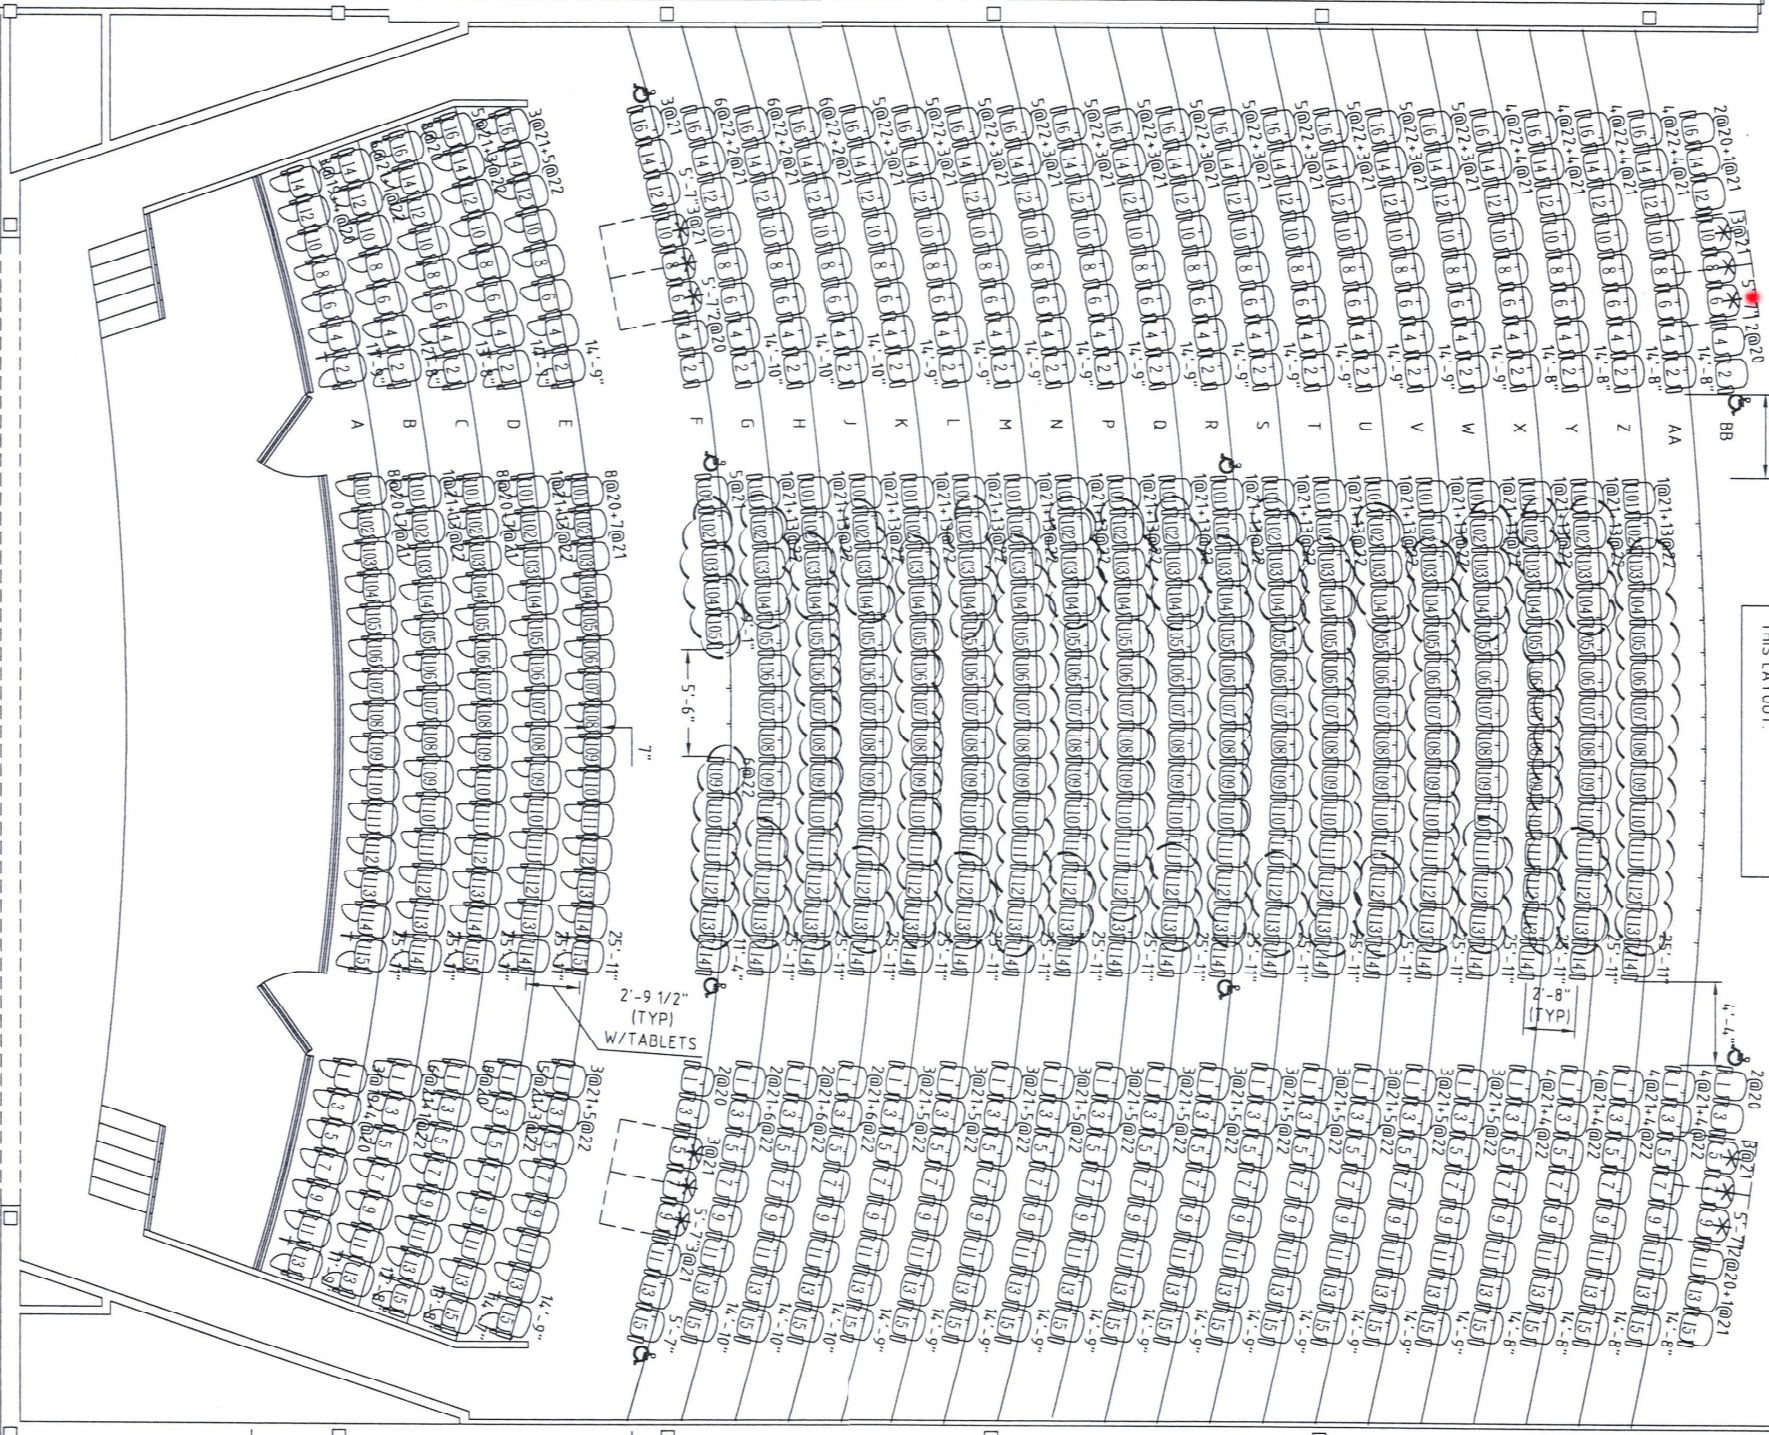
CLAUDED STANCHIONS WILL
 REQUIRE OFFSET PLATES TO
 AVOID EXISTING ANCHOR
 LOCATIONS. THERE ARE 186
 OFFSET PLATES REQUIRED WITH
 THIS LAYOUT.

20 ROWS - LOW RISE MOUNTED (ALL REMOVABLES ARE #0 FLOOR MOUNTED)
 USE EXTENDED SEAT FOAM IN ROWS F-BB

1 ROW
 #0 STN

5 ROWS - #0 FLOOR MOUNTED W/15° BACK PITCH
